## Silverware Drawer Magnets

| <b>Bulletin #(s):</b> | 25-013                                                                                                               | <b>Make(s):</b>          | Jayco       |
| <b>Job Code(s):</b>   | 9801635                                                                                                              | <b>Model(s):</b>         | Pinnacle FW |

| <b>Incident:</b>                   | Silverware tray magnet installed with ½" magnet instead of ¾" magnet |

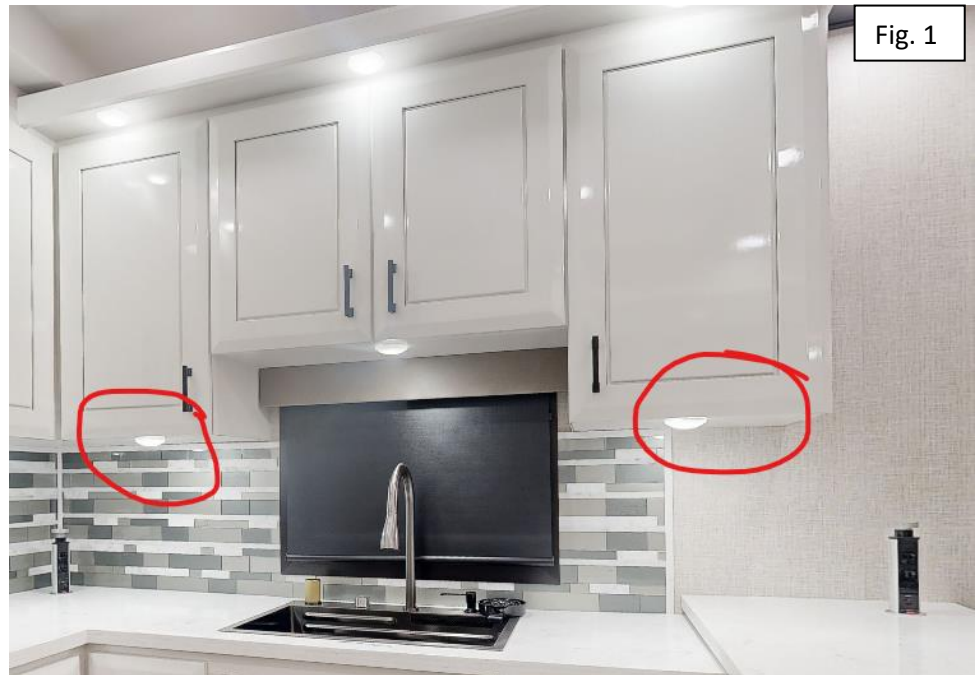
1. If the ¾" magnet on the left is installed, nothing more is needed. If the ½" magnet on the right is installed, proceed to change out with the ¾" magnet shown on the left.

| <b>Parts Kit:25-013JT</b>          | Parts Kit #: 25-013JT<br>4 EA - CATCH,MAG BRSS STK PL .75 90DEG BEND |
